# Mobile Intel<sup>®</sup> Pentium<sup>®</sup> II Processor Specification Update

Release Date: September 2006

Order Number: 243887-055

The Mobile Pentium<sup>®</sup> II processor may contain design defects or errors known as errata which may cause the product to deviate from published specifications. Current characterized errata are documented in this Specification Update.

Figure 1. TAP Gageable Thread Clarification

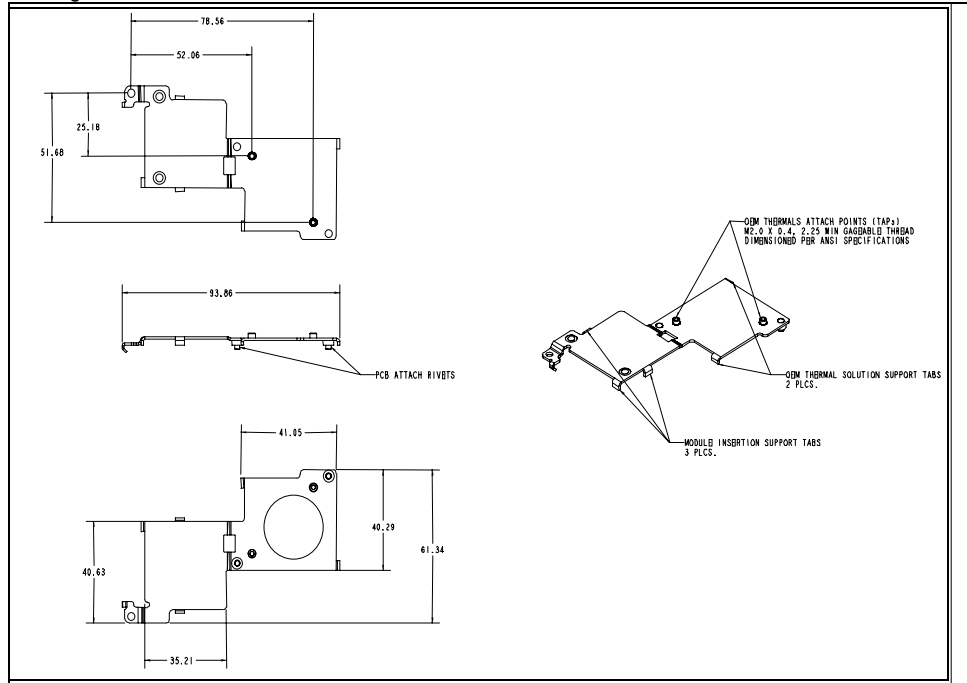
In the *Intel® Pentium® II Processor Mobile Module : Mobile Module Connector 1 (MMC-1)* and the *Intel® Pentium® II Processor Mobile Module : Mobile Module Connector 2 (MMC-2)* datasheets (Order Numbers 243667 and 243668, respectively), the thermal attach point (TAP) gageable thread specification was not clearly identified in Figure 14, of Section 5.2. The following is the TAP clarification:

OEM Thermal Attach Points (TAPs) M2.0 x 0.4, 2.25 min gageable thread dimensioned per ANSI specification.

See Figure 1 below for more information.
